216/23 ENU 6817

# Replacement Requirement for Center Console Support: Observing Special Procedure when Replacing Component (216/23)

Model Line: Cayenne (9YA)

Concerns: Center console support

Example of identification of part number for cover for the tray (center armrest)

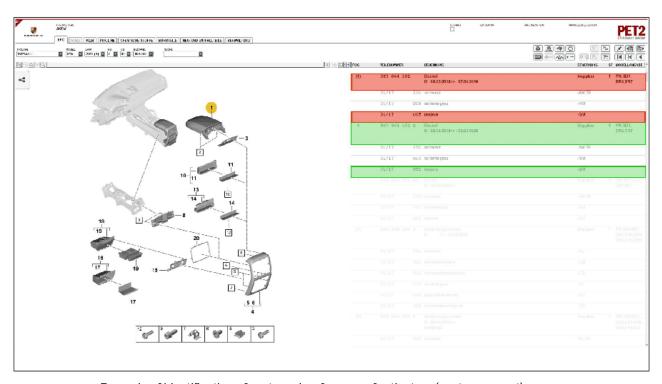
The cover for the tray (center armrest) compatible with the new center console support is listed directly under the cover for the tray (center armrest) provided for the vehicle. This is greyed out, but is still to be used.

The part number highlighted in **red** in the graphic is the cover for the tray (center armrest) provided for the vehicle in the Porsche spare parts catalogue (PET2) but **not** compatible with the **new** center console support.

The part number highlighted in **green** in the graphic **or** its interpretations are compatible with the **new** center console carrier.

4.3 Determine and order the compatible cover for the tray (center armrest) using the graphic.

**Red** – Cover for the tray (center armrest) provided in Porsche spare part catalogue (PET2)

**green** – Required and compatible cover for the tray (center armrest)
